Re: Harmony Subdivision Sections 4, 5, 6 & 7, Primary Plat Application – Waiver Requests  
IECI Job No. 14115

# HARMONY SECTIONS 4, 5, 6 & 7 DRIVEWAY SEPARATION VARIANCE EXHIBIT

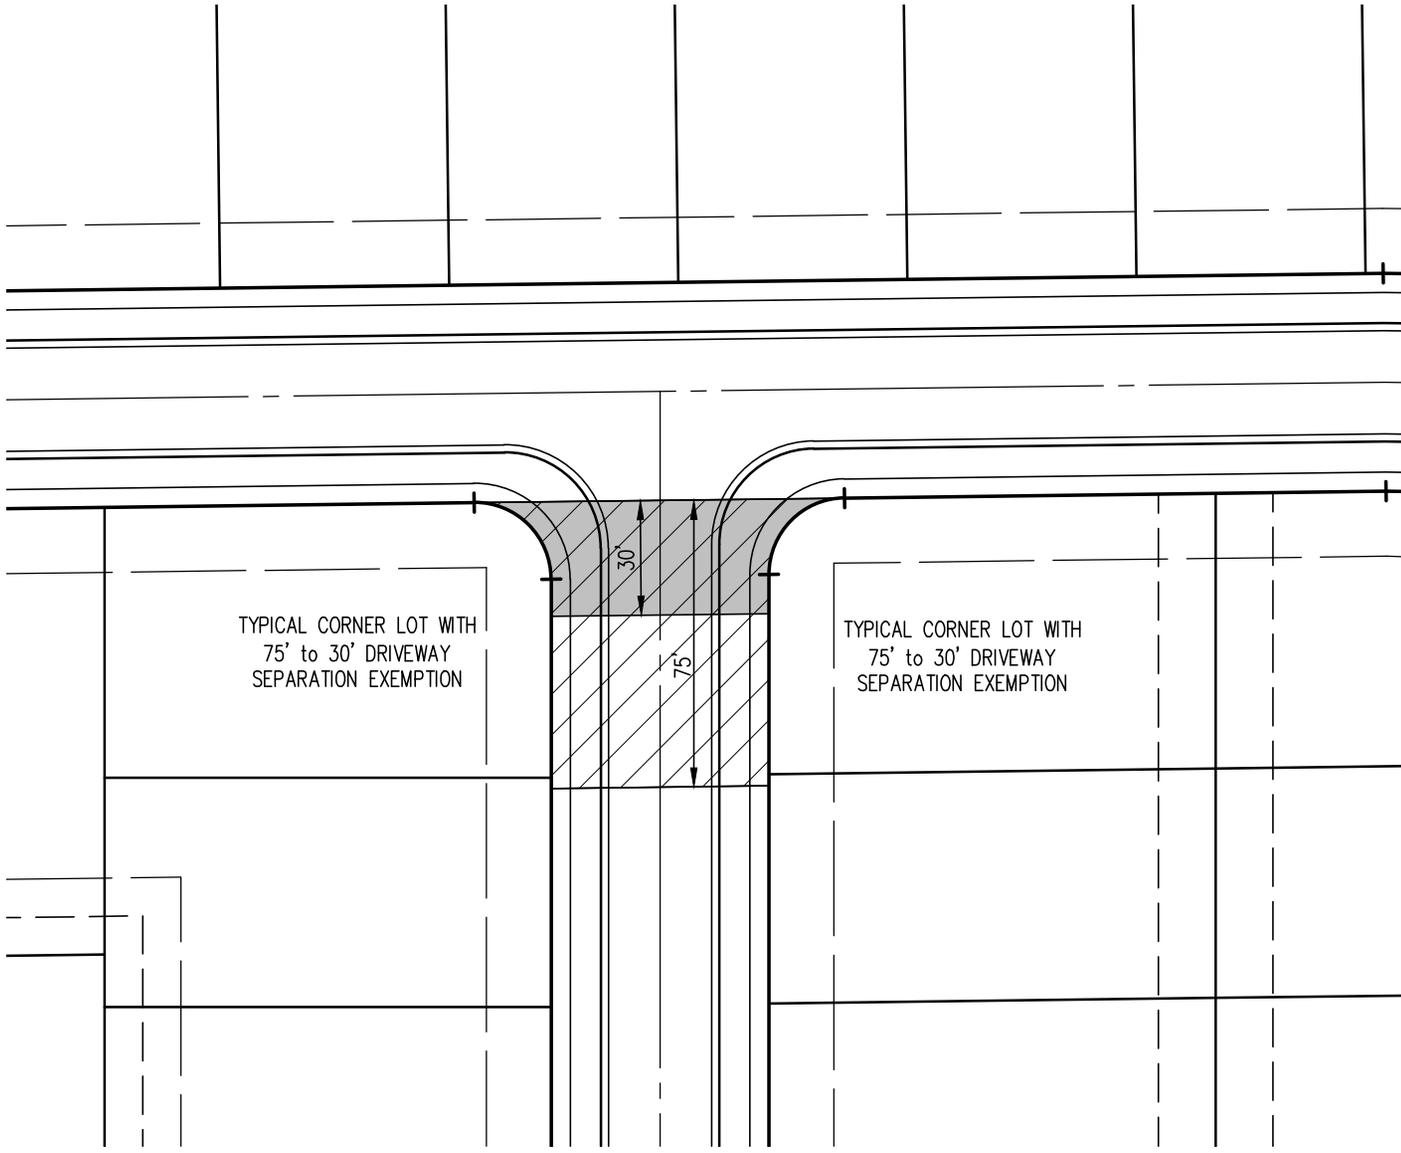
1. Centerline Radius – Section 02501 – Standards of Roadway Geometric Design
  - a. Section 1.1 B 4 a - Minimum radius required: 150.0 ft.
  - b. Proposed radius: 100.0 ft
2. Driveway Separation – Section 02501 - Standards of Roadway Geometric Design
  - a. Section 1.1 C 7 b - Minimum separation required: 75 ft
  - b. Proposed separation: 30 ft

Due to the size of this Primary Plat submittal, 471 lots, this situation occurs in several locations. As the design evolves with the Secondary Plat, lot numbers are highly likely to change. Therefore attached to this letter is a lay-out sketch, “Driveway Separation Variance Exhibit”, that shows the typical situation where the Variance will be applied.
